CRYSTAL RIVER UNIT 3

PILOT PLANT AUDIT REPORT

ANALYSES REQUIRED FOR THE RESPONSE

TO GENERIC LETTER 2004-02

Figure 2 Crystal River Top Hat Strainer Array Top View.

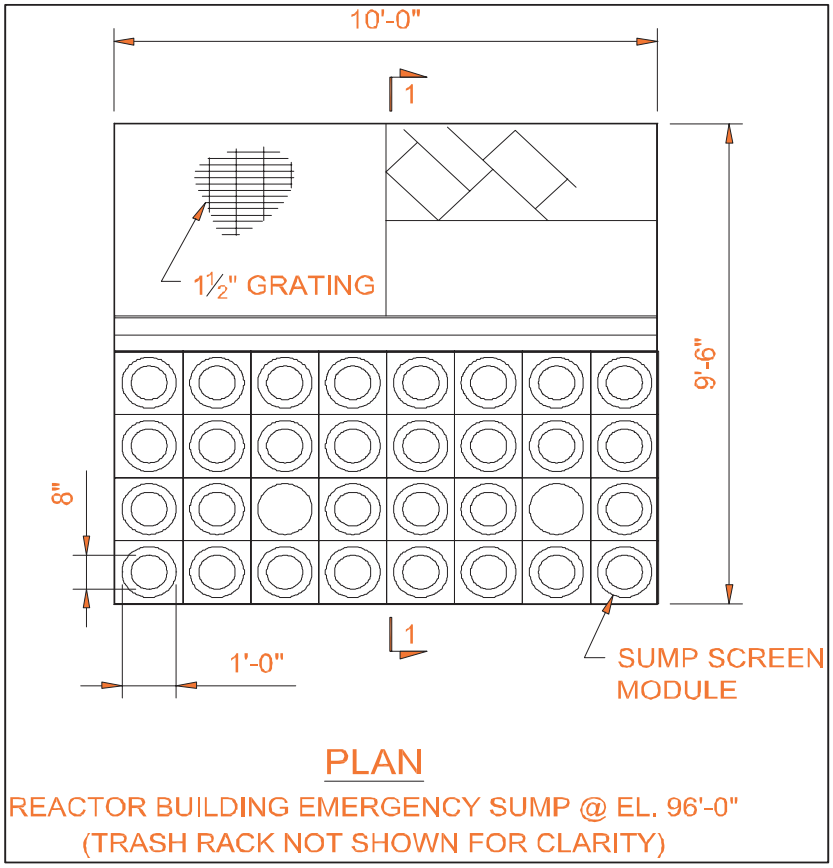
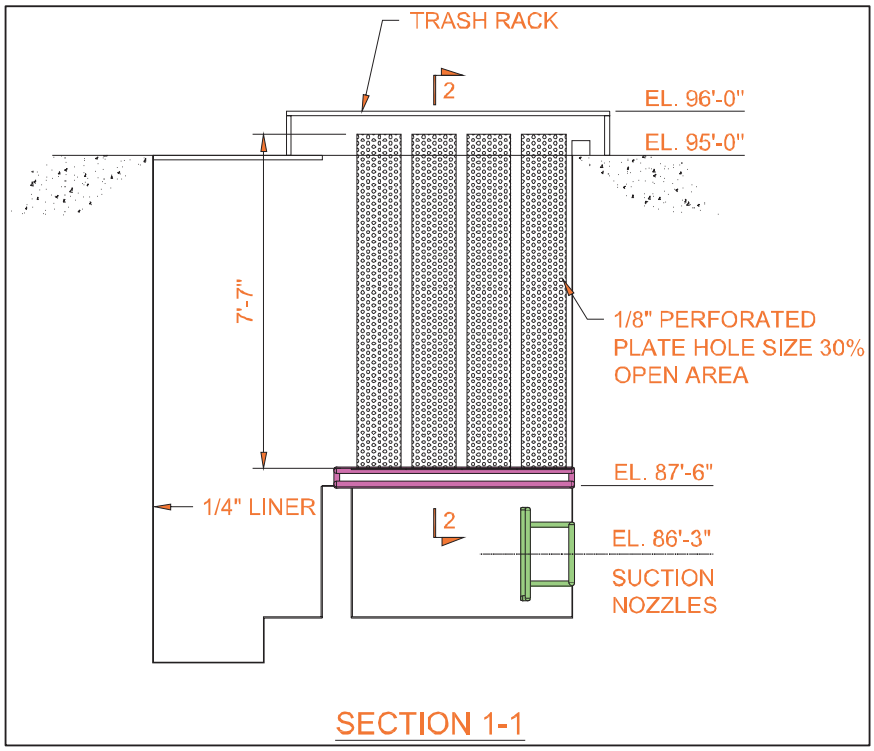
The licensee did not provide any scaled test data to justify the conservatism of the uniform debris bed distribution assumption. Based on the flow field within the top-hat strainer array, one could assume a non-uniform bed formation. The licensee should justify the assumption technically.
